Cut-Through and Qcc Bridge Delay Model

Christian Boiger
christian.boiger@b-plus.com
IEEE 802 Plenary
November 2016
San Antonio, TX

Current Status of IEEE P802.1Qcc

Why is cut-through not compatible with the IEEE 802 architecture?

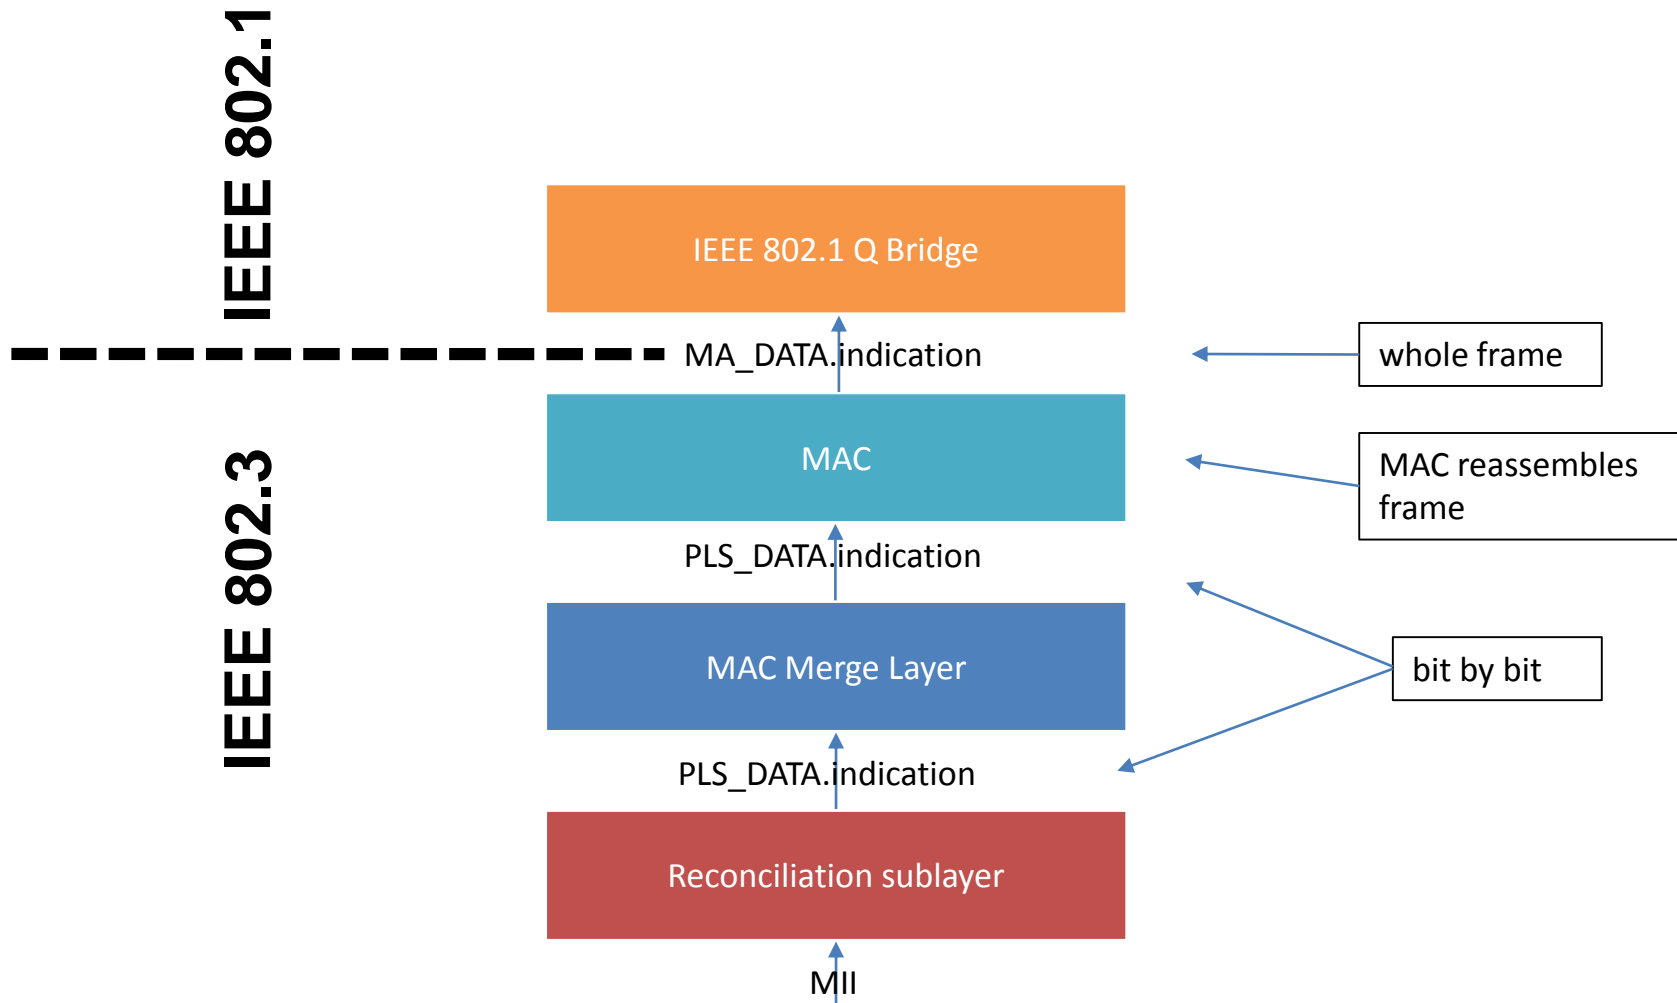
- The interface between 802.1Q and lower layers is described by the MAC service interface, defined in IEEE 802.1AC
- The MAC service interface is defined in a way that a whole frame is presented to the upper or lower layer (not Bits or Bytes)
- The interactions between the two layers are defined as atomic
- Only error free frames issue a M_UNITDATA indication, frames with FCS errors are dropped by the MAC and never pass the MAC relay

“All error-free received user data frames give rise to M_UNITDATA indication primitives. A frame that is in error, as defined by the relevant MAC specification, is discarded by the MAC Entity without giving rise to any M_UNITDATA indication”

- IEEE 802.1Q states:

“The minimum additional transit delay introduced by a Bridge is the time taken to receive a frame plus that taken to access the media onto which the frame is to be relayed. Note that the frame is completely received before it is relayed as the Frame Check Sequence (FCS) is to be calculated and the frame discarded if in error.”

e.g. 1000BASE-T1:

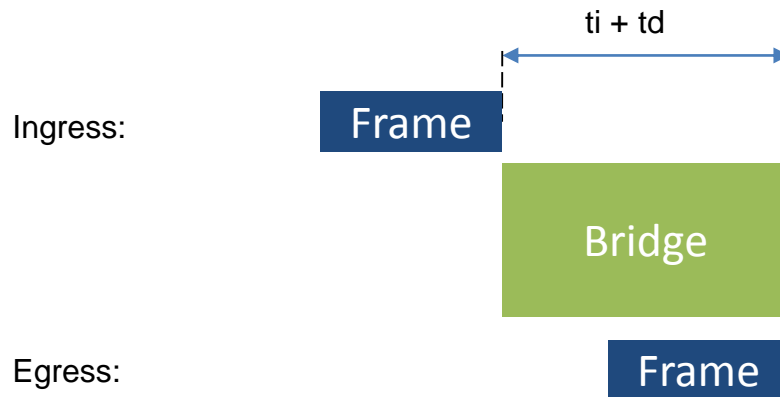
- In case the current definition is meant to be relative to the timestamp reference plane it is incorrect
- PHYs can have delays that are higher than a minimum size frame.
- → With the current definition those PHYs would never be able to support cut-through (according to the current definition) which is not true

“The sum of the transmit and receive data delays for an implementation of a 1000BASE-T1 PHY shall not exceed 7168 bit times (14 pause_quanta or 7168 ns)”

Example – Cut-Through

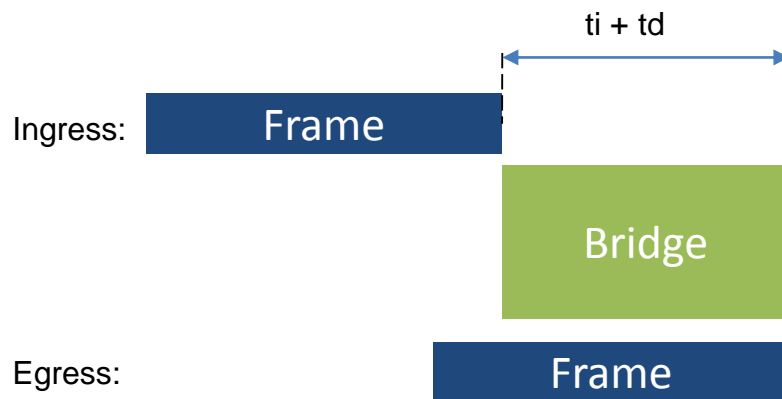
- Cut-through
- 10 Gigabit links
- cutThroughDelayMin/Max (per Qcc D1.1) = 480 ns / 500 ns

- Frame length independent delay component (t_i): 480 ns / 500 ns
- Frame length dependent delay component (t_d): 0 ps/Byte / 0 ps/Byte
